PRELIMINARY ASSESSMENT RESPONSE – 1/2024/PLP

This letter has been prepared by Urbis Ltd on behalf of Stockland Development and Allam Property Group (the proponent group) in relation to the West Gables Planning Proposal (1/2024/PLP) and the proposed amendment to the Hills Shire Local Environmental Plan (HLEP 2019), relating to land at 93-105 & 109-113 Old Pitt Town Road, 1, 2 & 4 Cataract Road, and 145 & 151 Boundary Road, Gables.

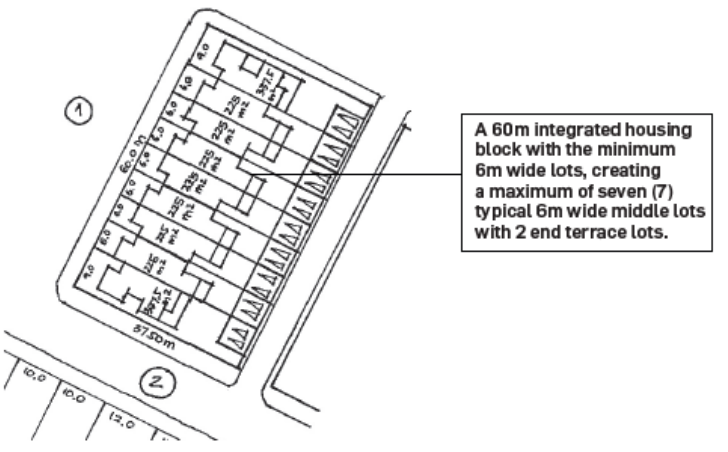
Matter	Council Comment	Response
		<p>in accordance with the controls. Therefore, a blanket application of 225m² lots would be inconsistent with the land use arrangement in the ILP.</p> <p><u>Zoning:</u> The Gables is already an established medium density residential environment. West Gables has been designed to function as an extension of Gables, whilst also being a distinct community in its own right. Despite the R3 zoning, housing and lot sizes in Gables have tended to skew towards detached housing and larger lots as a result of demand, with attached housing and smaller lots occurring less frequently. These same market conditions are expected to prevail over West Gable as well. Regardless, when assessing applications for 225m² integrated housing lots, Council will need to have regard to the objectives of the zone, which are:</p> <ul style="list-style-type: none">▪ To provide for the housing needs of the community within a medium density residential environment▪ To provide a variety of housing types within a medium density residential environment <p>Therefore, the assessment of the application will need to determine whether it contributes to a “<i>medium density residential environment</i>” and a “<i>variety of housing types</i>”. Therefore, applications proposing an excessive amount of 225m² integrated housing lots, would be inconsistent with the objectives of the R3 Zone and not in the public interest as it would, for example, not result in a variety of housing types.</p> <p>Urban Design Analysis</p>

Matter	Council Comment	Response
		<p>As evidenced in the Lot Testing Pack, a blanket use of the 225m² integrated housing lot size is not achievable across the various typical street blocks across West Gables. This is namely due to the street block widths, depths and road layout.</p> <p>The deepest lots within West Gables are typically 35m, meaning that future lots cannot have a drastically narrow lot width when compared to the proposed standard residential lots (300m² – 700m²) which will make up the majority of West Gables in accordance with the ILP. The Integrated housing lots, in most instances, will have a width greater than 6m (in between 7-9m), with a lot size in between 225m² and 285m².</p> <p>For example, in Area 1 under Scenario D in the Lot Testing Pack (refer Figure 1 below), a 60m street block identified for integrated housing under the ILP is shown. A subdivision of this block would likely result in a maximum of seven (7) typical 6m wide lots, 225m² in size, with two larger lots on the corners, at 9m wide and 335m² in size.</p> <p>Figure 1: Area 1, Scenario D</p>

Matter	Council Comment	Response
		<p>AREA 1 - SCENARIO D</p>  <p>It was also intended that all the requirements under Clause 4.1B of the HLEP 2019 would apply to subdivisions seeking a reduction in lot size down to 225m² in accordance with Sub-Clause 4. Therefore, to clarify, it is proposed to insert the following text under the Sub-Clause 4 (new text in red):</p> <p>(a) Notwithstanding Clause 4.1B (3) (b), development consent may be granted to a single development application for the subdivision on land zoned R3 Medium Density Residential for a lot equal to or greater than 225 square metres, however, that development consent must not be granted under this clause, unless: The development application is for both of the following:</p> <p>(i) The subdivision of land into 3 or more lots, and</p>
